Docket Items #14 & #15
BAR CASE # 2017-0238 &
2017-0239

BAR Meeting
July 19, 2017

ISSUE: Permit to Demolish/Capsulate, Certificate of Appropriateness for alterations

LOCATION: 217 Green Street

EXISTING GREEN STREET FACADE & PARTIAL SITE PLAN SHOWING PROPOSED DEMOLITION

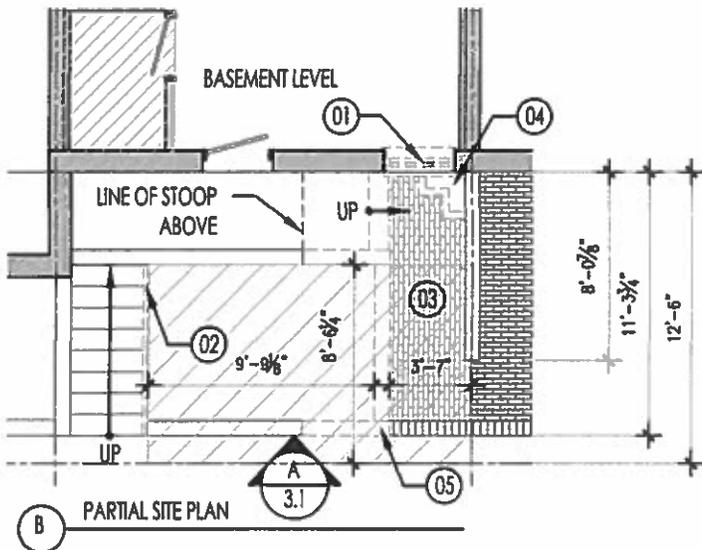
Demolition is limited to a brick retaining wall in the front yard. After the wall is demolished the front patio will be enlarged.

In the opinion of Staff, none of the above criteria are met. This is a middle-unit, mid-20th century townhouse and the demolition is limited to a landscape feature, with no remarkable or unusual features and the materials of the wall are modern, hard-fired brick. The wall could easily be reproduced in the future.

PROPOSED GREEN STREET FACADE & PARTIAL SITE PLAN

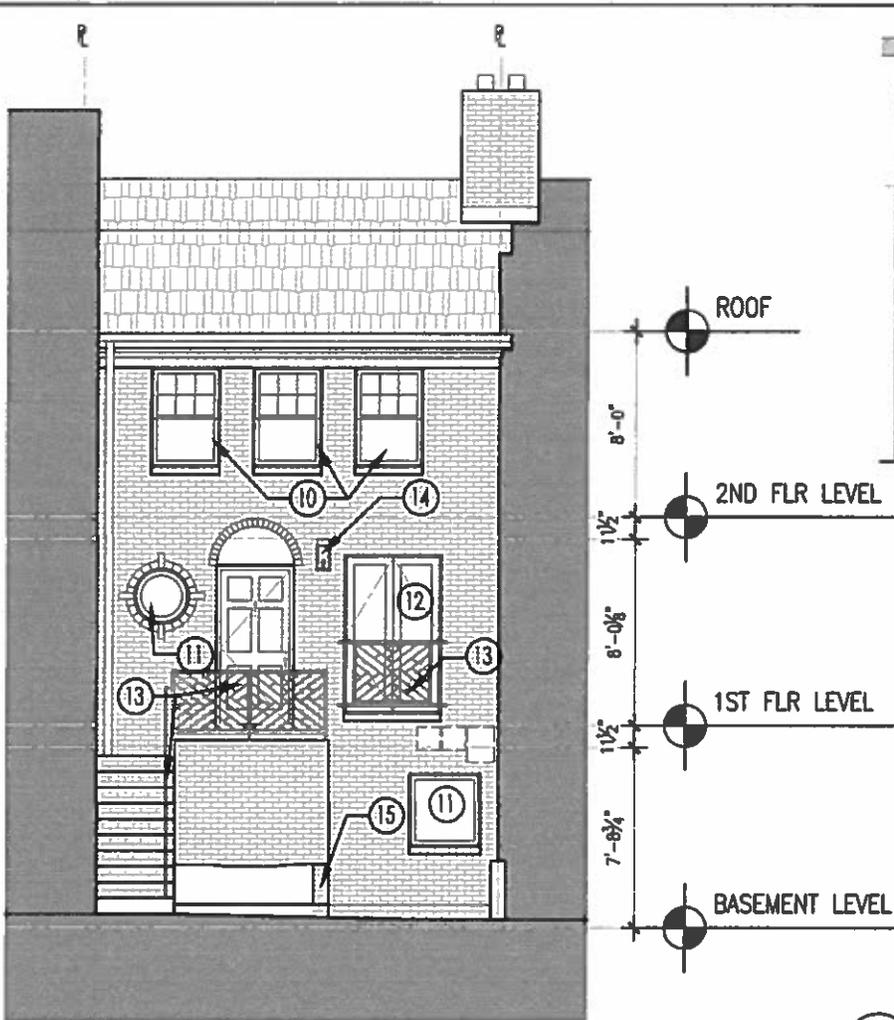
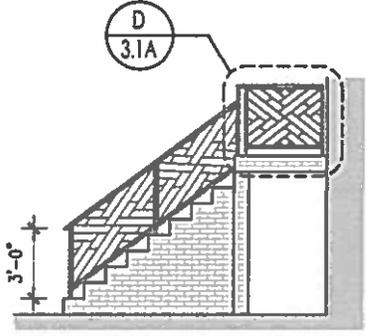
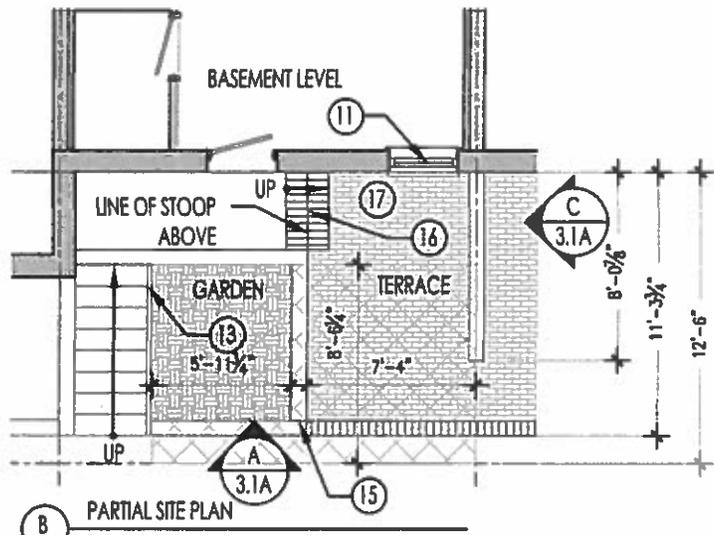
1. The replacement windows and doors be simulated-divided-light, aluminum-clad;
2. The double-hung windows have a six-over-six configuration, not a six-over-one configuration as shown on the plans;
3. The new in-swing patio doors have a multi-light configuration; and,
4. That the oriel window be retained or replaced with a multi-light configuration.

While staff supports the replacement window cladding material, staff does not find that the proposed light configuration of the double hung windows, six-over-one, or the single-light in-swing doors and the oriel window, is appropriate on this vernacular Colonial Revival style townhouse. Of all building features, windows are probably the most character defining feature of the house and have been described as the eyes of a house. Changing the style of the fenestration can drastically change the appearance of a building. For these reasons, nationally accepted preservation policy encourages window styles to reflect the period of significance of that portion of the building.

The use of a six-over-one window sash configuration is more common on Arts & Crafts style houses but was also used on Colonial Revival style buildings during that same early 20th century period. However, staff is not aware that this window style was ever used in Yates Gardens. Likewise, single-light windows in the 20th century are often associated with more contemporary architectural styles. While many townhouses in the Yates Garden development have been altered over time – some with additions, new windows and doors – almost all have maintained the more traditional multi-light pattern and staff recommends that this be continued here to provide texture and scale and to help unify this facade.

The combination of the multiple sizes and proposed window styles, along with the Federal Revival style railing, gives the building a somewhat erratic appearance that is not helping achieve a unified architectural composition. Staff recommends approval of conversion of the 16-light picture window to a pair of French doors and of the addition of the Federal Revival style Jeffersonian-Chippendale railings. These railings are an appropriate Colonial Revival feature and a vast improvement over the existing railings. However, staff recommends that all of the aluminum clad wood replacement windows and French doors have the same or a similar multi-light configuration as the existing windows.
